Proposed PD - For Review

ISSUE DATE:
March 12, 2020

Re: Center Stage Planned Development
Keller, Texas

Concept Plan Changes

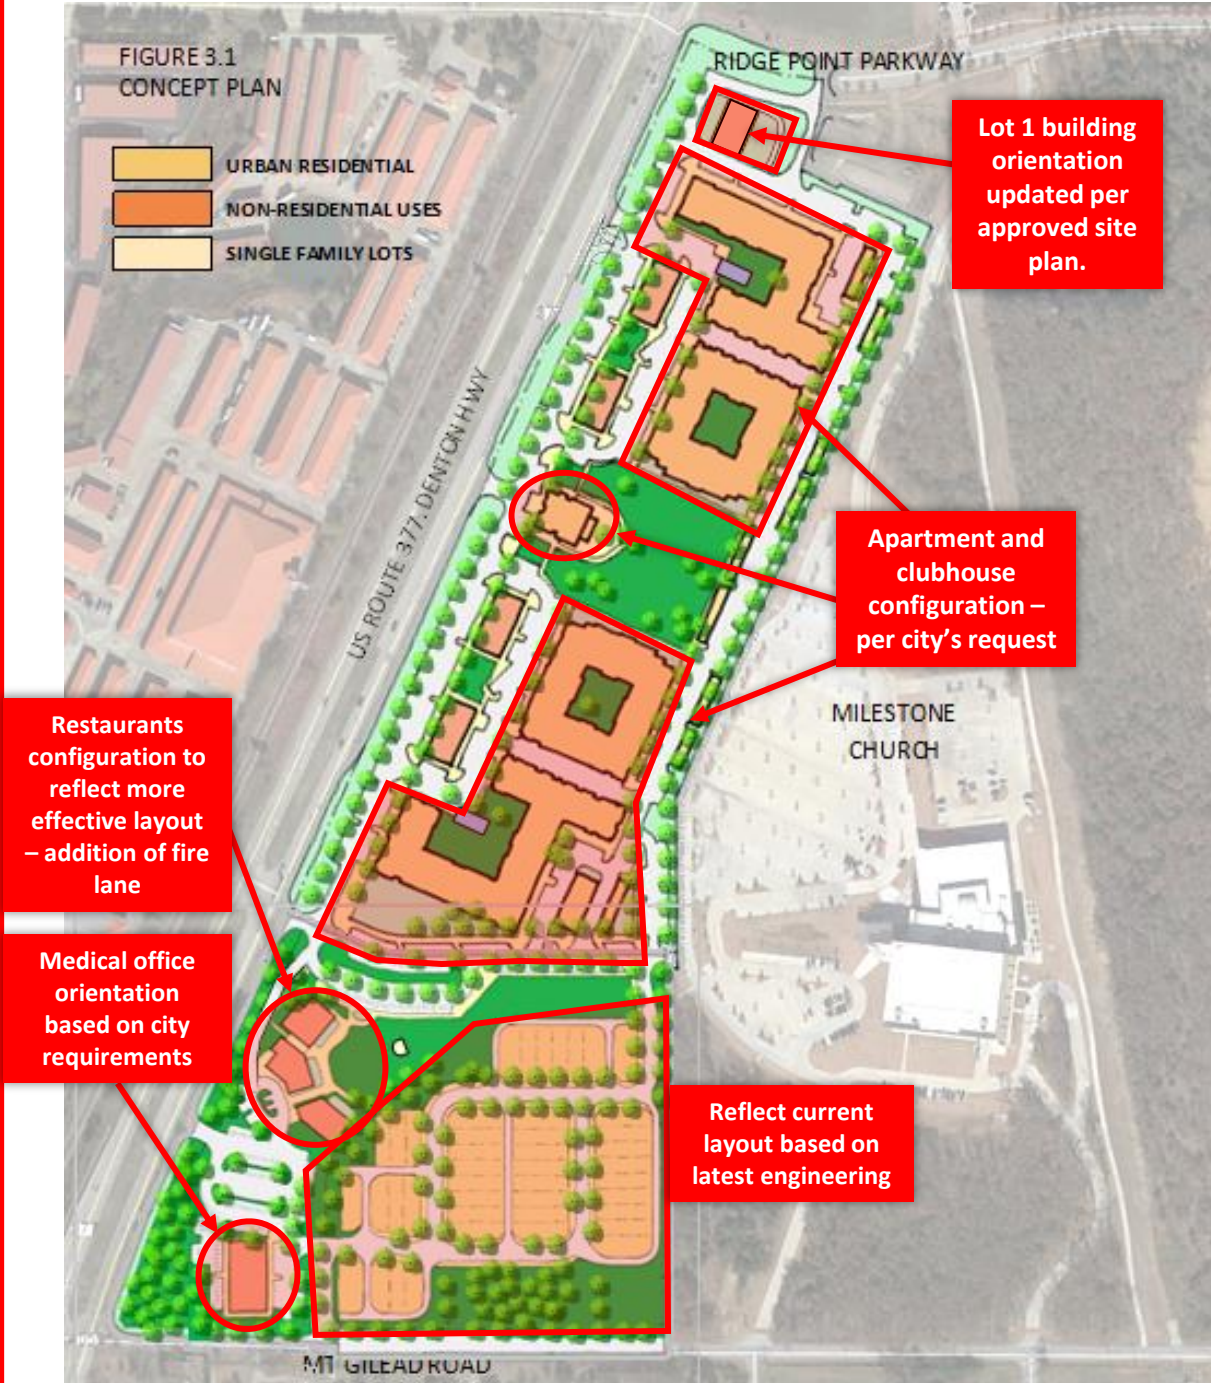
(P11): updated figure 3.1 concept plan

Regulating Plan Changes

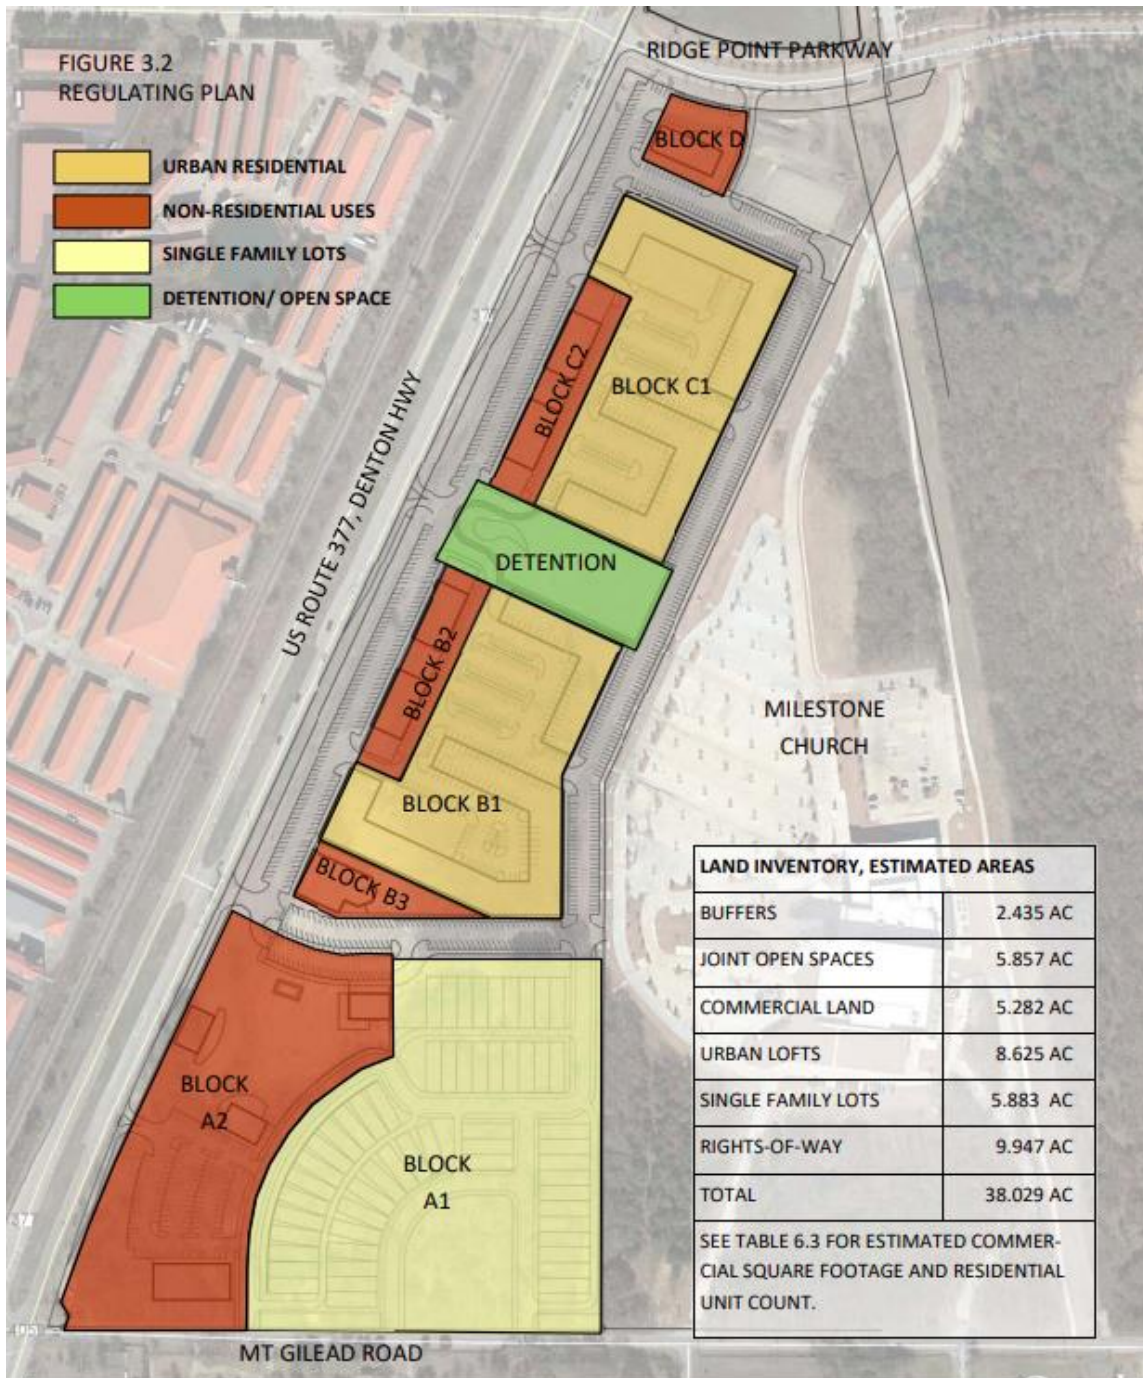
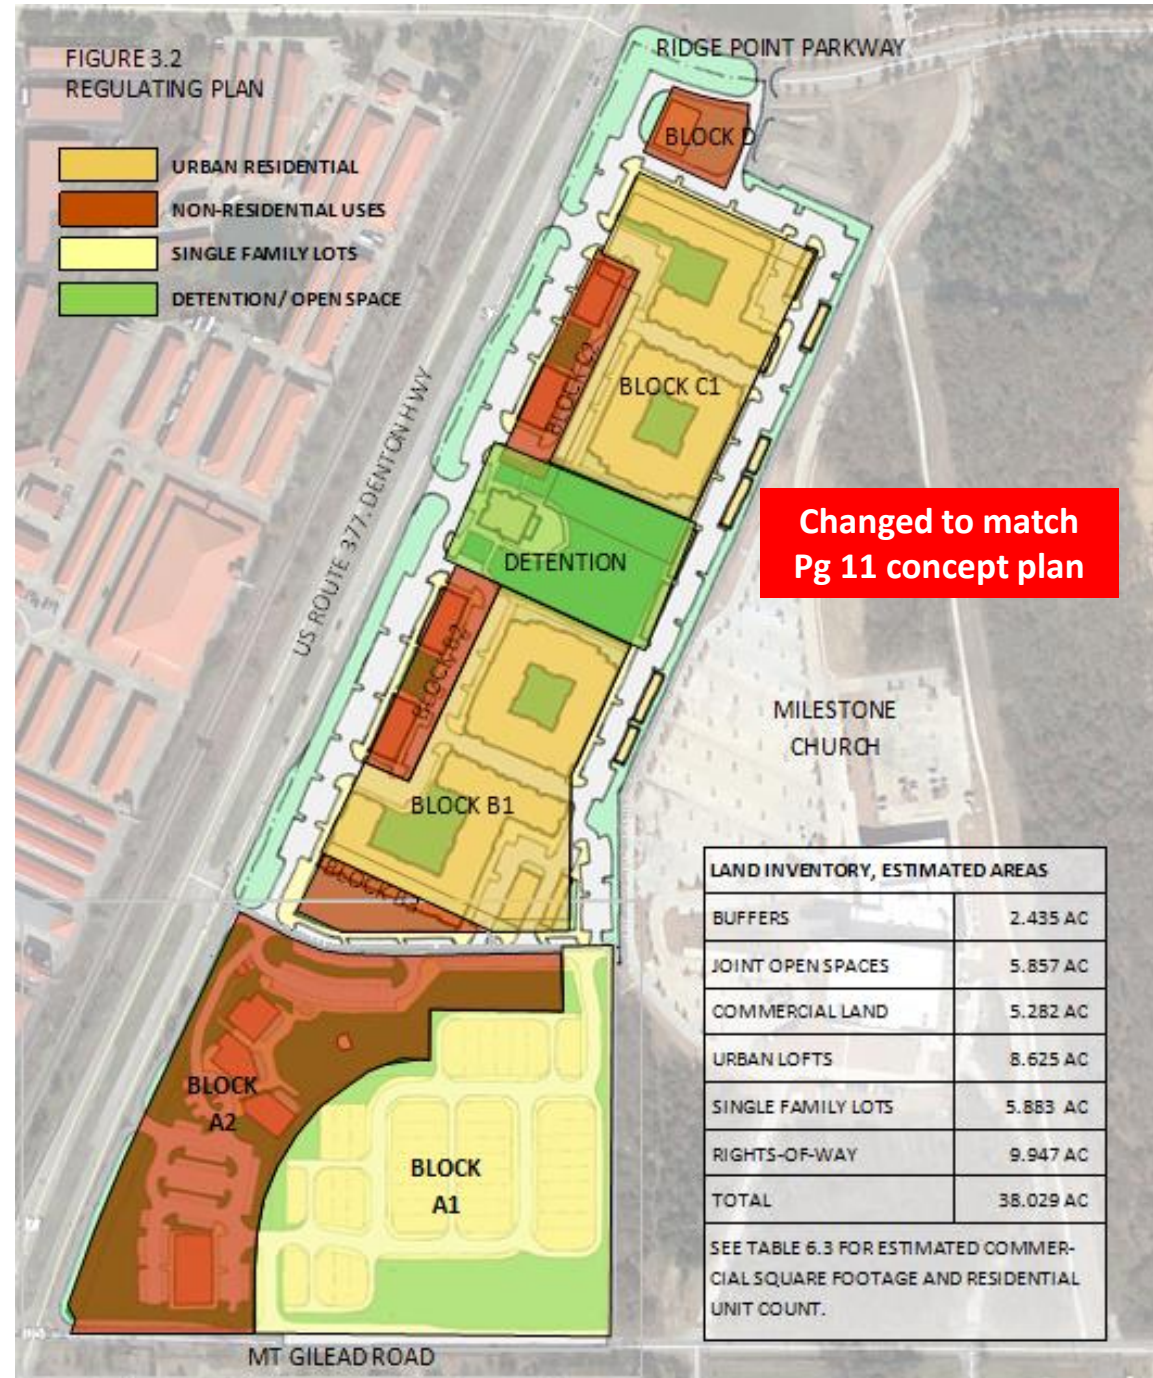
(P12): updated figure 3.2

Street Plan Changes

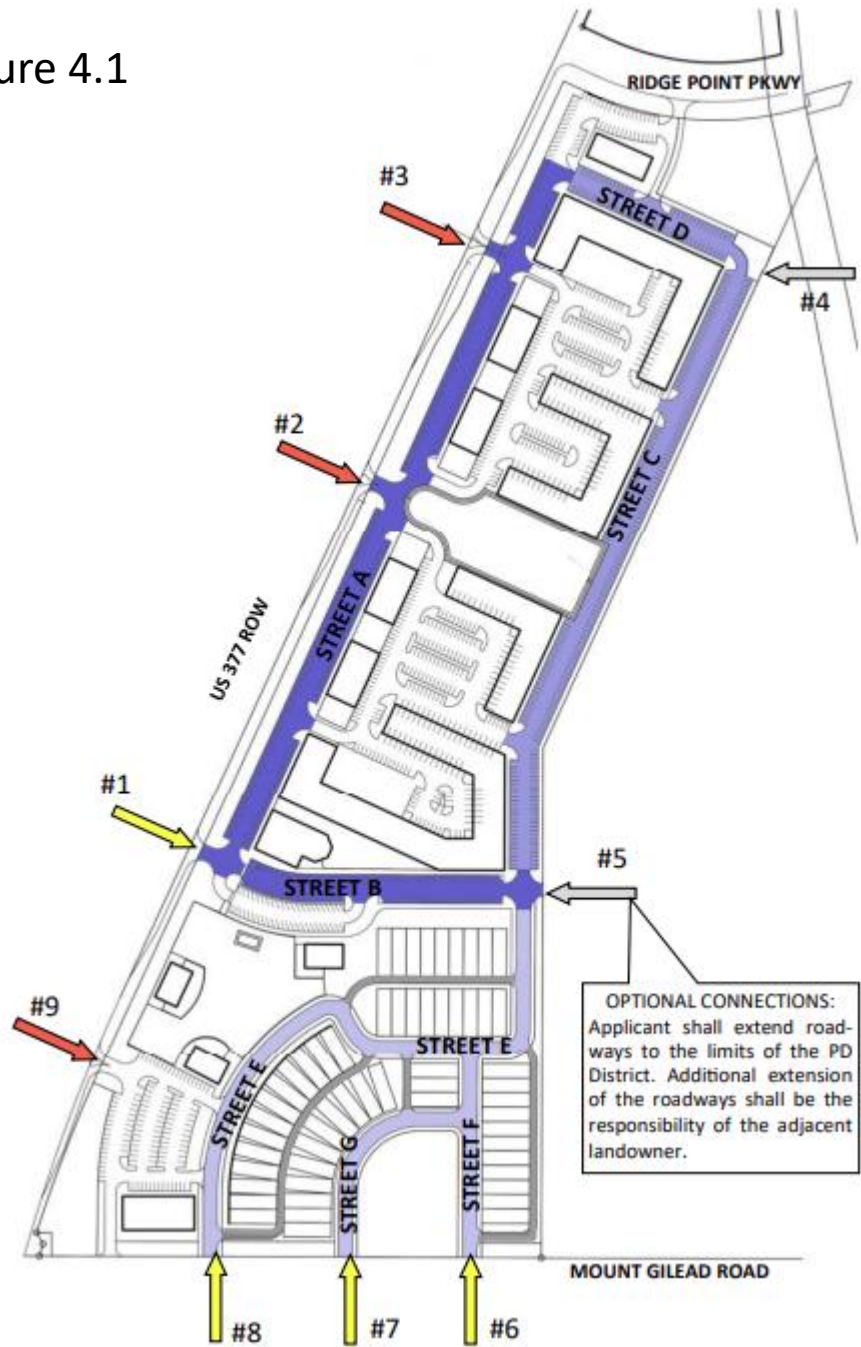
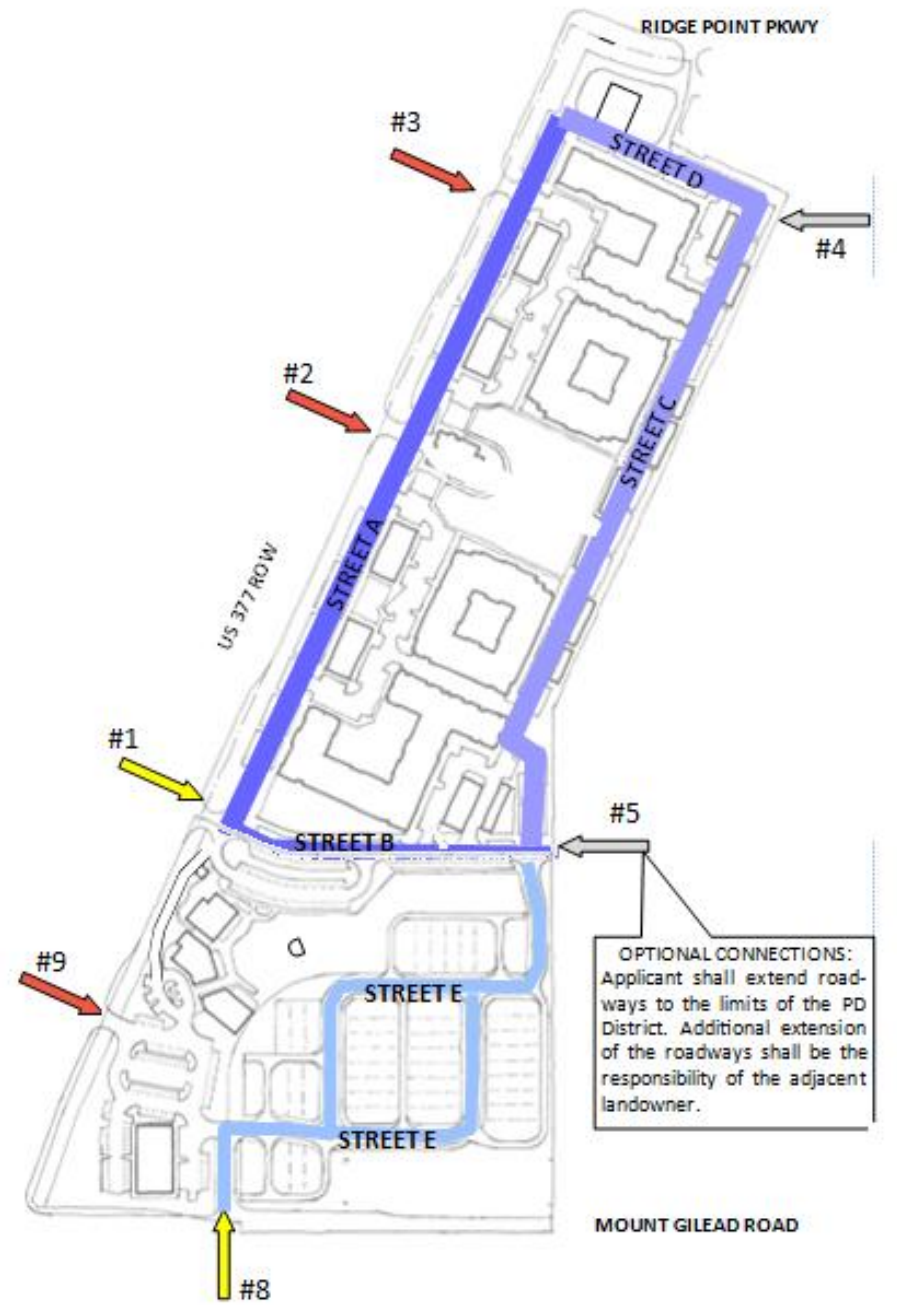
Removed Streets G and F, given new single family home configuration and plan consistent with concept plan on Pg 11".

(P16): Updated Note 4 to remove reference to Streets F&G, updated Figure 4.1

Street Legend Changes

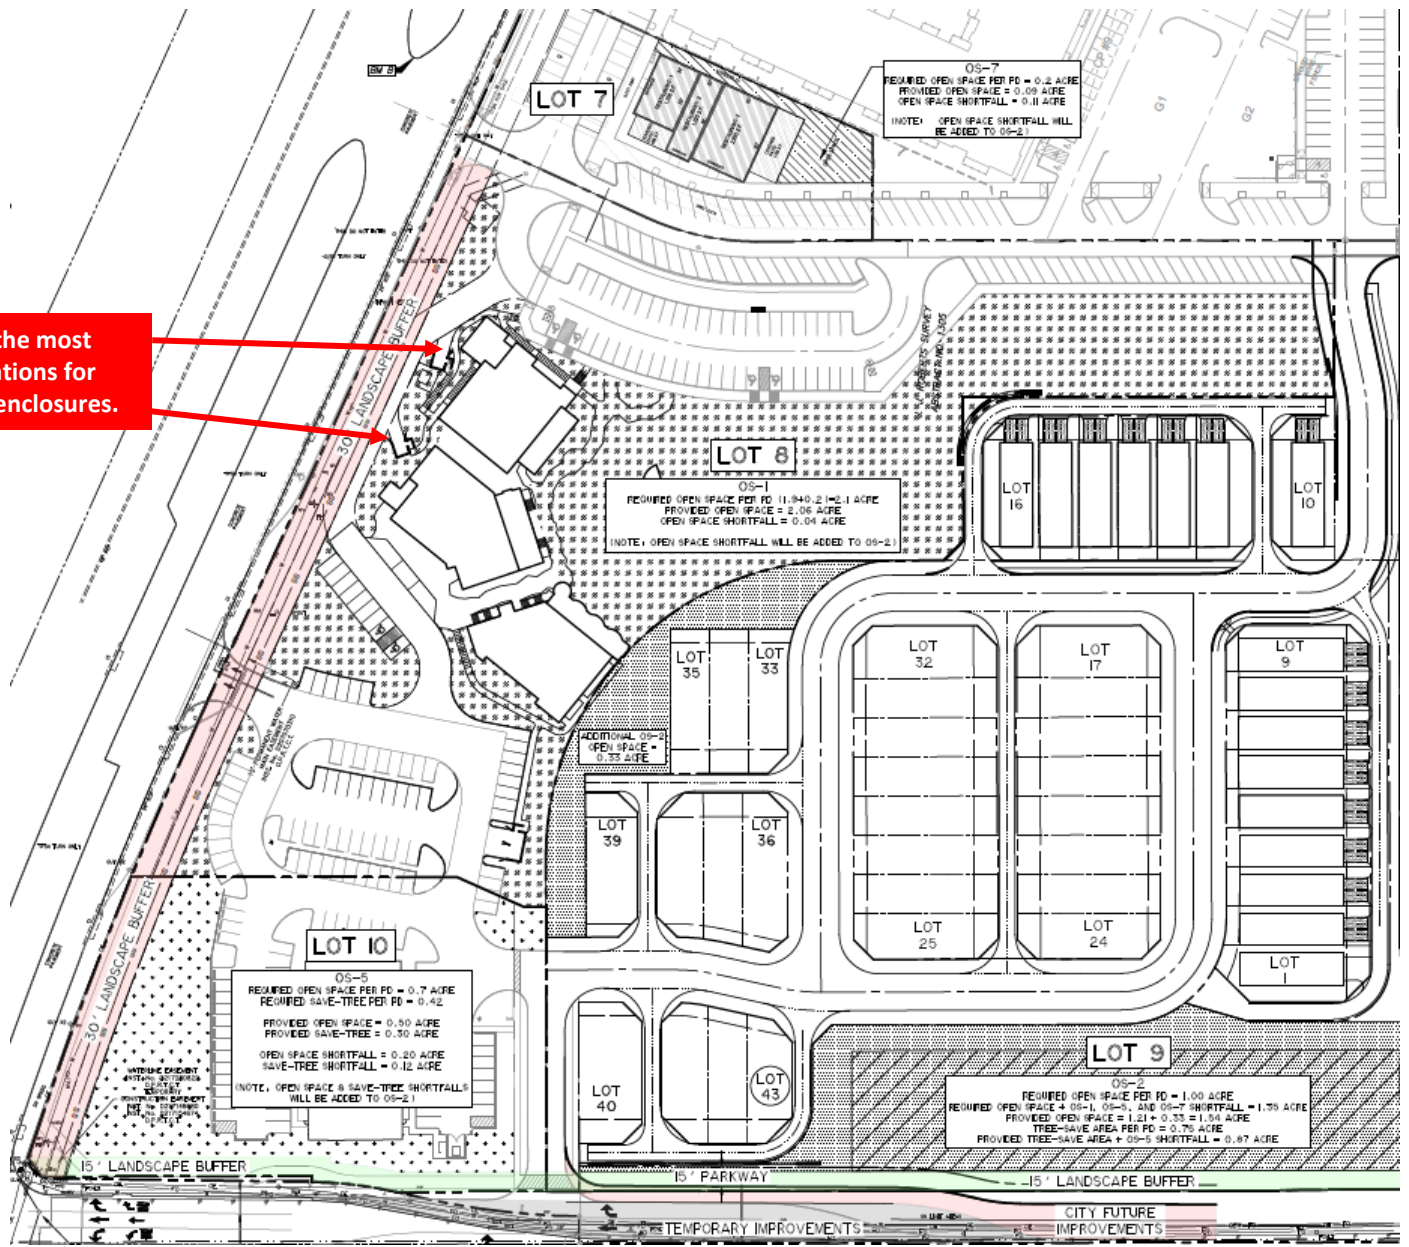
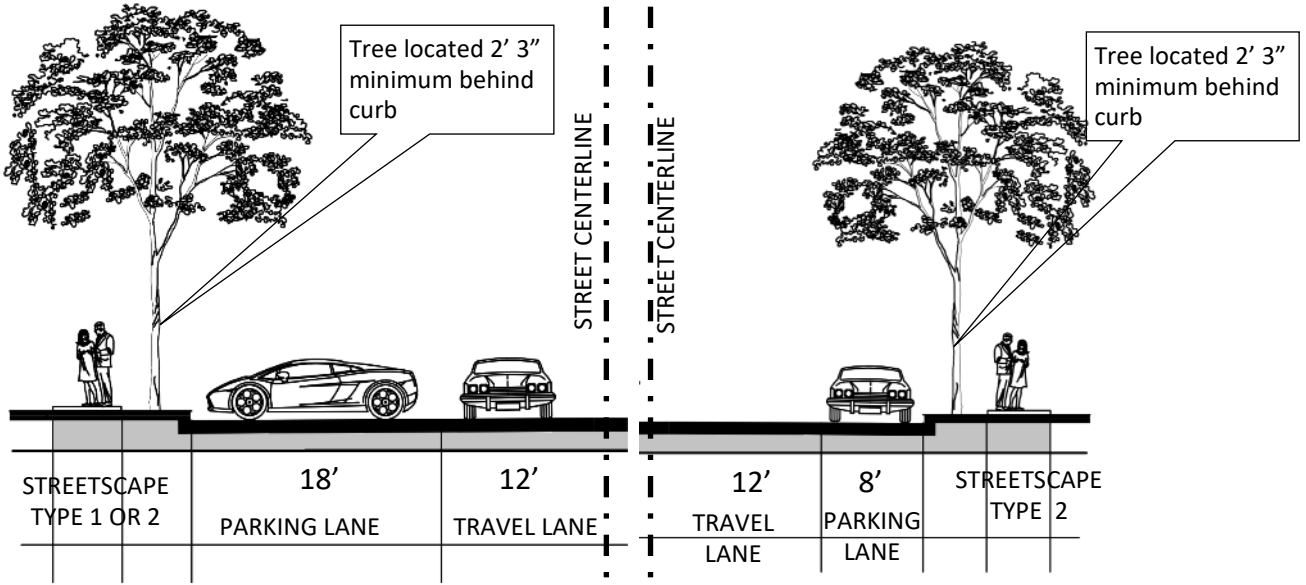
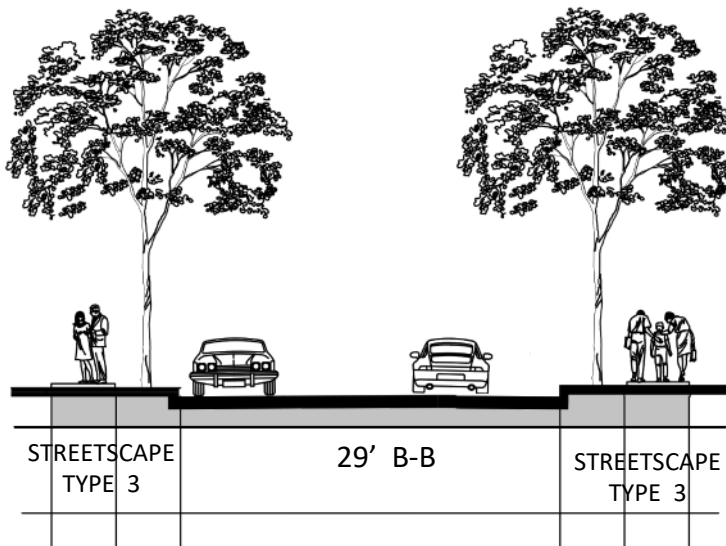
Updated Table 4.1 to remove streets F & G, added note permitting dumpster enclosure along 377 in Block A2 so long as it is screened by landscaping, meets pedestrian access and materials requirements and meets trash vendor's access requirements

*A dumpster enclosure may be installed along 377 in Block A2 so long as it is screened by landscaping, meets pedestrian access and materials requirements and meets trash vendor's access requirements.

These are the most logical locations for dumpster enclosures.
